## **SM\_A810S\_REV0.4**

Model: SM-A810S Revision: REV04

## VX\_Setup(2016-01-20)\_HHP

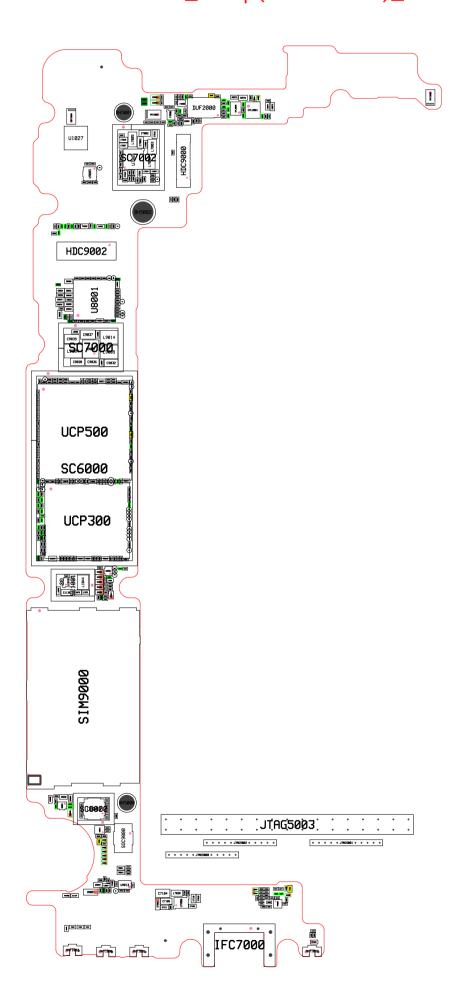
AON1605(TR7001): IT'S Wrong Polar ity possibility. Check the Pin1

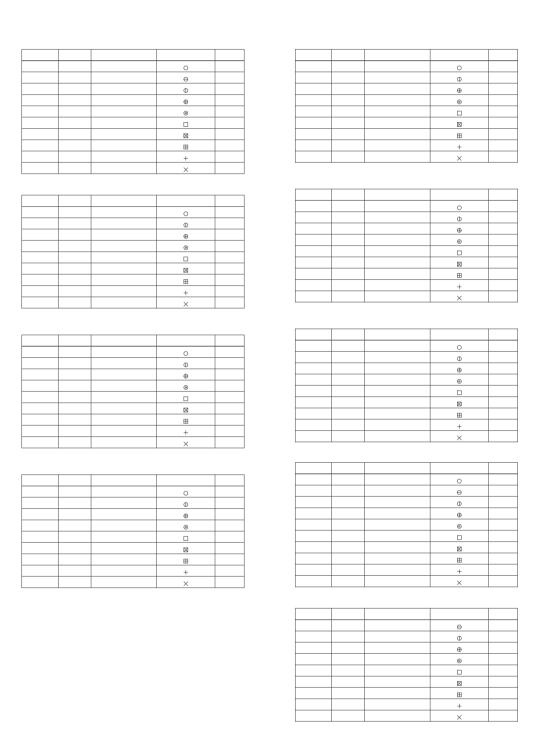
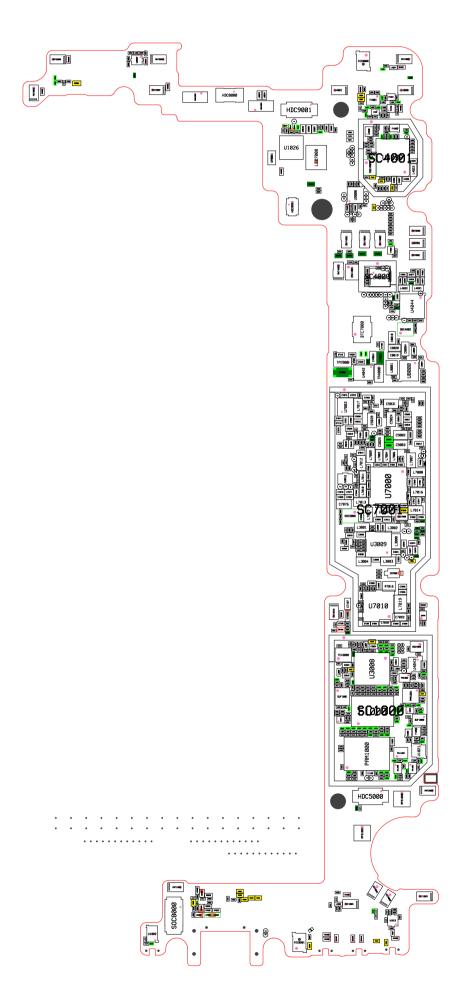
AON1605(TR7001): IT'S Wrong Polar ity possibility. Check the Pin1
